English summary of GTS' written view to the NC TAR draft code amendment decision as published on 5 March 2018 by ACM. GTS submitted its formal view in Dutch to the ACM on 25 May 2018. This English summary is for information purpose only.

1. Introduction

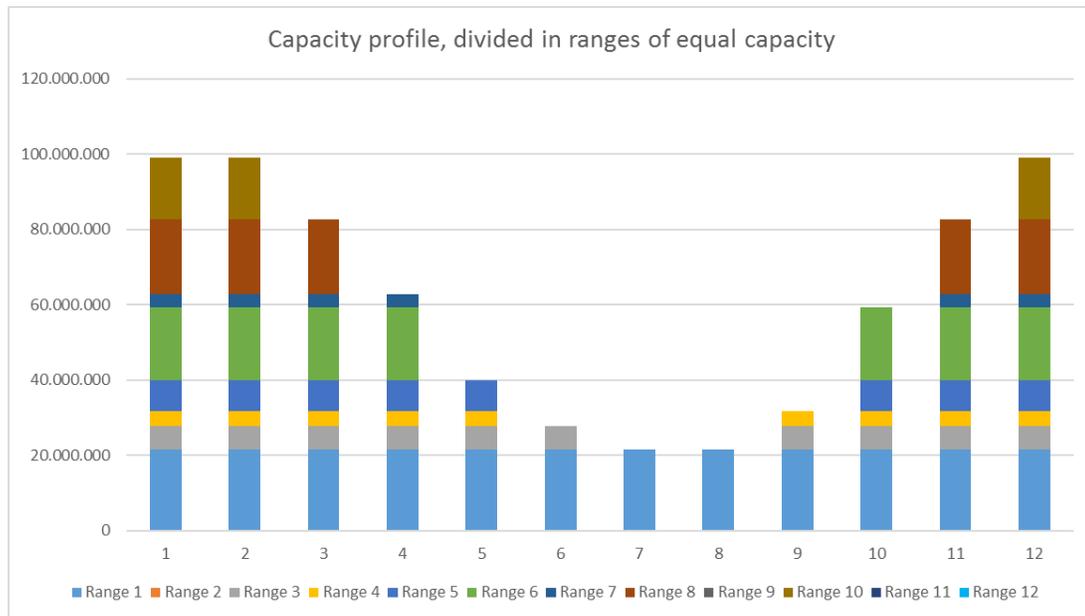
range if the sum of the shorter-term capacity products is more expensive than the longer-term capacity product (even though they were not planning to use that capacity in all months in advance). See below for a typical RNB profile the "grey" range (range 3).

If this grey range 3 had to be contracted according to the capacity profile with quarterly products (Q1, Q2, Q4) and monthly products (September), this would cost approximately 1.14 * the annual tariff. The shipper who has the choice himself then proceeds to purchase the annual capacity product for that range. The same mechanism can be used for the other ranges. De facto this 'product optimization' leads to an optimal booking consisting of standard capacity products with standard prices. In short: the shipper is able to realize the tariff optimization proposed by ACM through product optimization. GTS sees one possible "disadvantage" being the fact that for financial reasons capacity is booked that may not be used (possible hording). However, if we look at the current profile and period bookings, we can distinguish three groups:

GTS, on the basis of the above analysis and consideration, proposes the following text changes:

Article 3.2.3.8 (Tariff Code):

"In case a network user on the same day contracts entry or exit capacity at domestic entry and exit points in any combination of quarterly, monthly and daily capacity products, and at request of the network user, GTS will handle as follows per capacity range:

- a. If the price to be paid for the combination of quarterly, monthly and daily capacity products is higher than the price of an annual capacity product, the annual capacity product will be contracted for that range;*
- b. If the price to be paid for a combination of monthly and daily capacity products within one gas quarter is higher than the price to be paid for the relevant quarterly capacity product, the relevant gas quarter product is contracted; and*
- c. If the price to be paid for a combination of daily capacity products within one gas month is higher than the price to be paid for the monthly capacity product for the relevant gas month, the relevant monthly product is contracted."*
